December 6, 2019

PROJECT NUMBER 17163

**Re: D12-444 D14-1674 750 Lockhart Road – Response to Comments
Draft Plan of Subdivision**

SCALE: 1 : 400		PROJECT No.
DATE: NOVEMBER 2019		17163
DESIGNED BY: S.R.	DRAWN BY: S.R.	FIGURE No. VMD-13
CHECKED BY: M.D.	CHECKED BY: M.D.

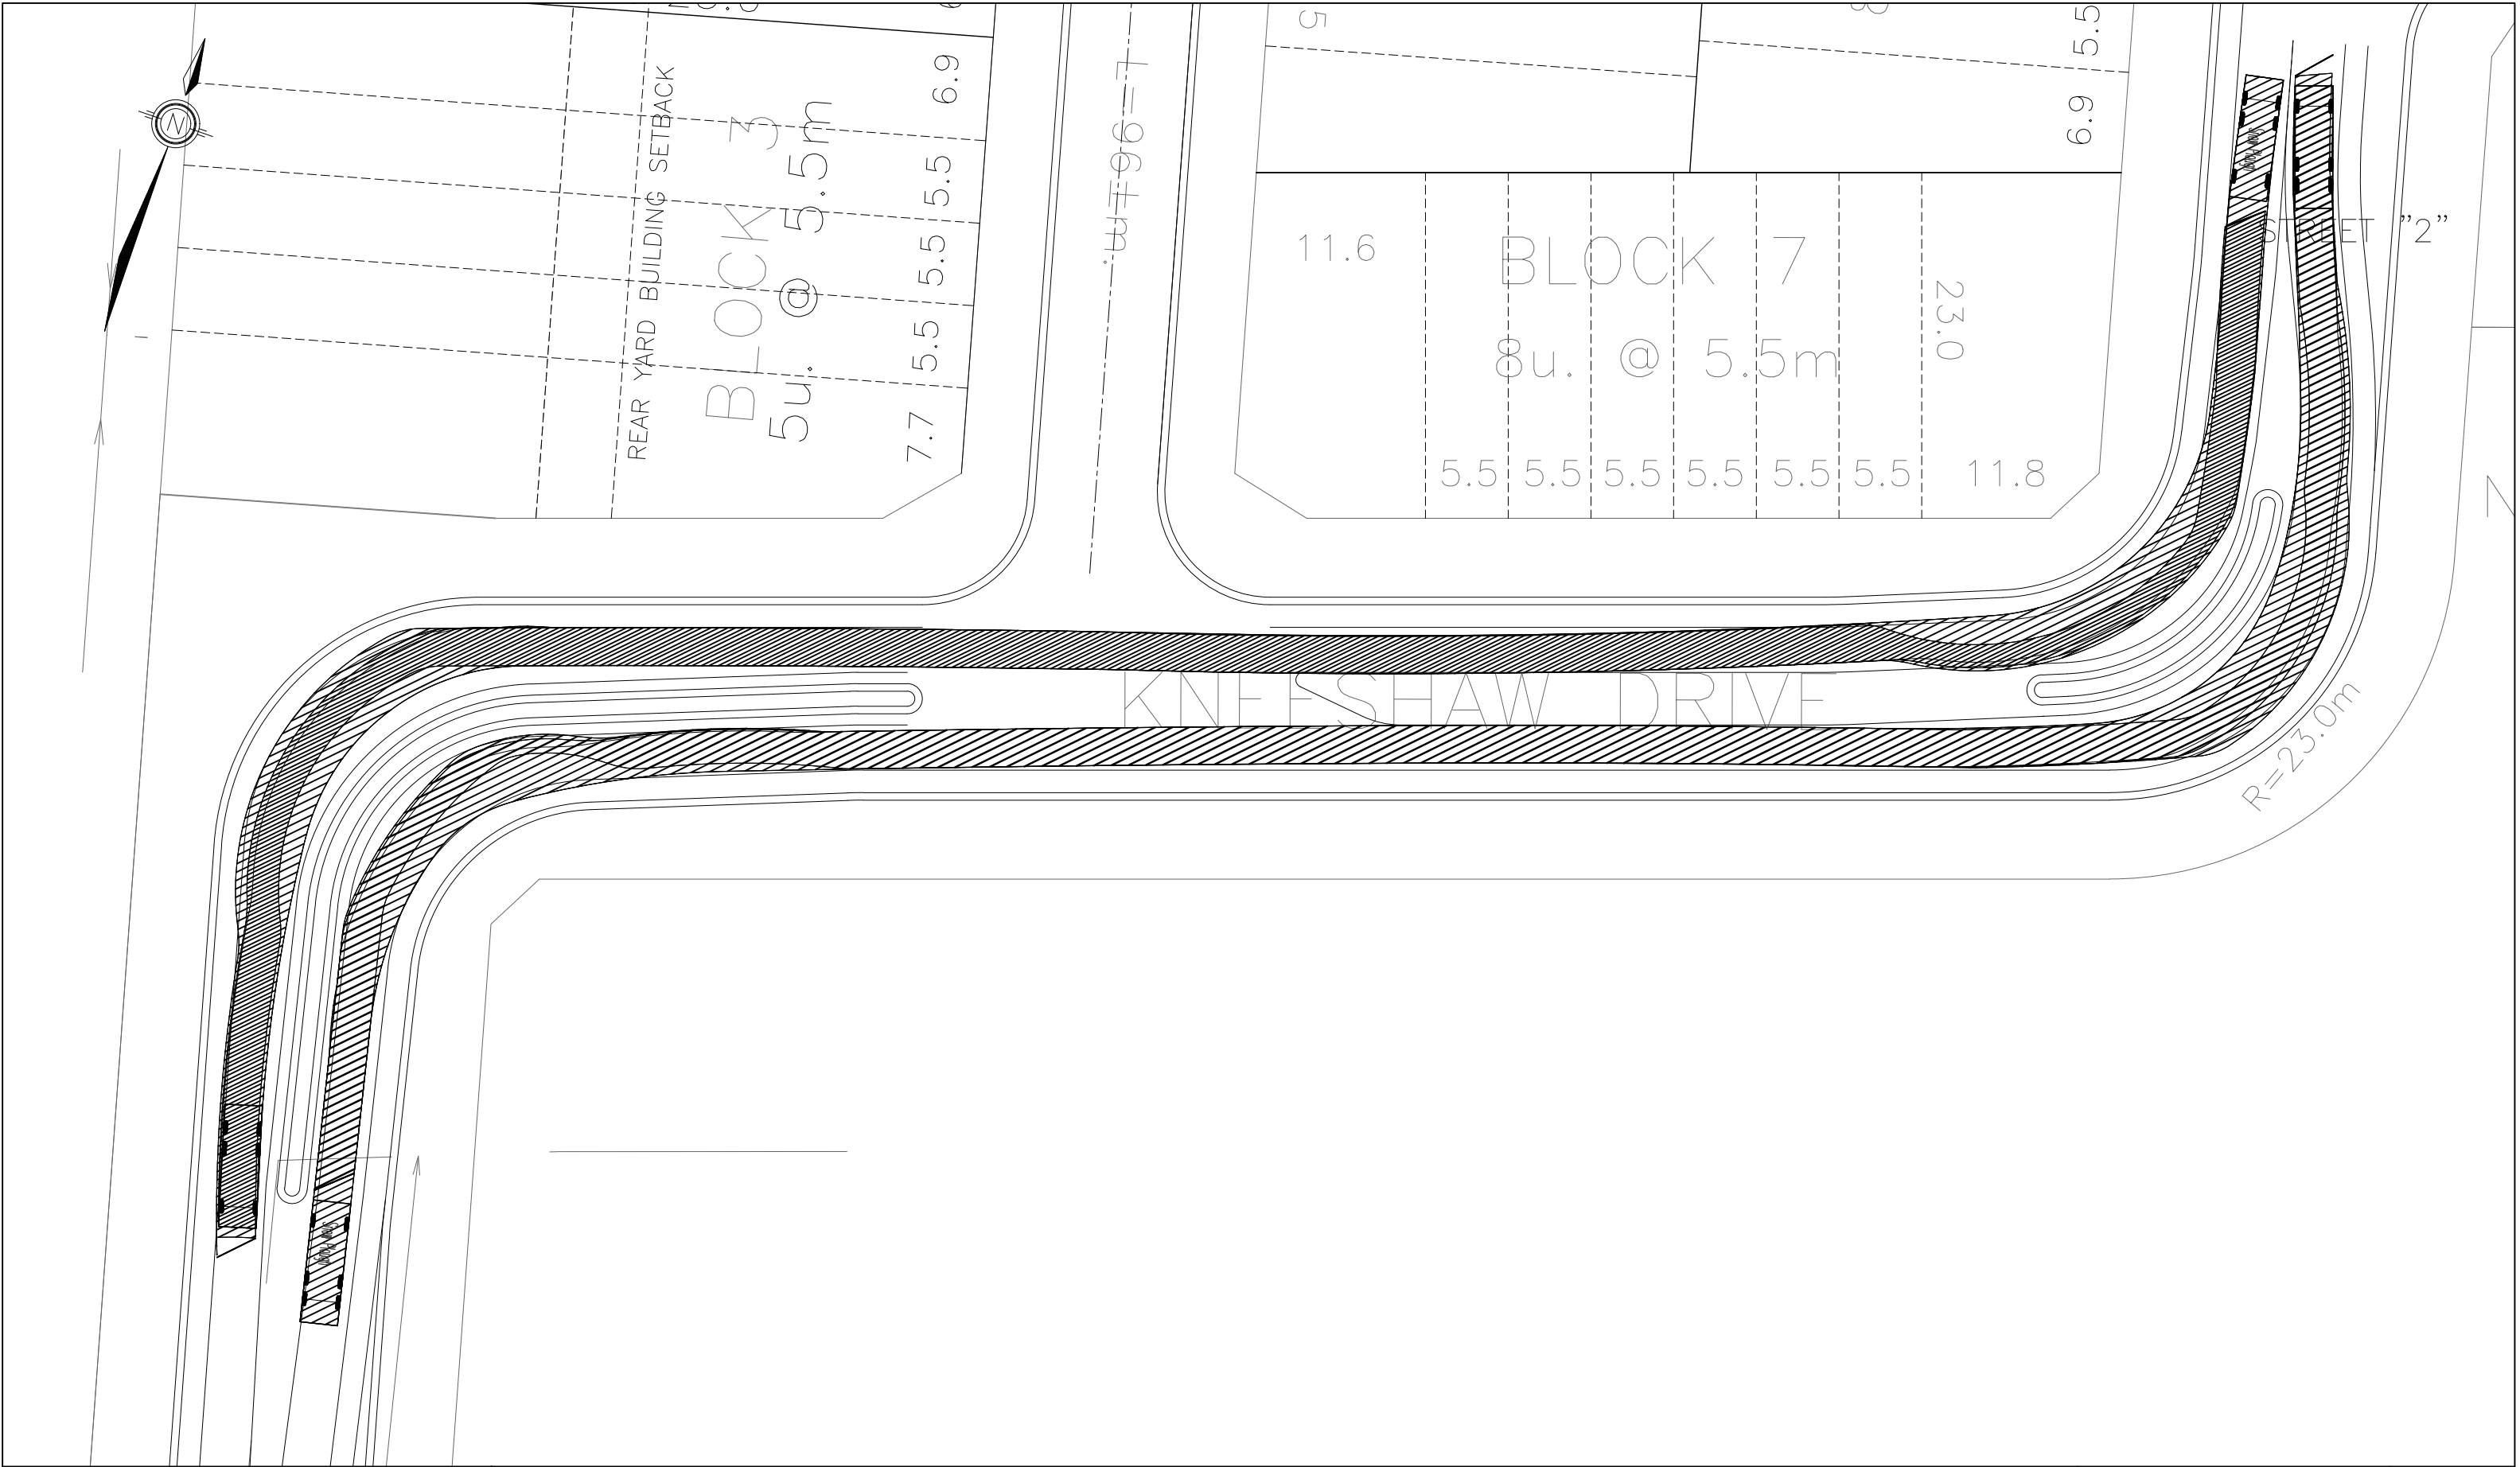
Comment 1: The applicant shall provide turning template to ensure maintenance vehicles are able to navigate the proposed traffic calming features

*Response: Please see attached Vehicle Movement Diagrams **VMD-1** to **VMD-13** that provide navigation of an emergency vehicle (fire), intercity bus, and snow plough through the proposed traffic calming features. All vehicles comply with standards provided by the City of Barrie.*
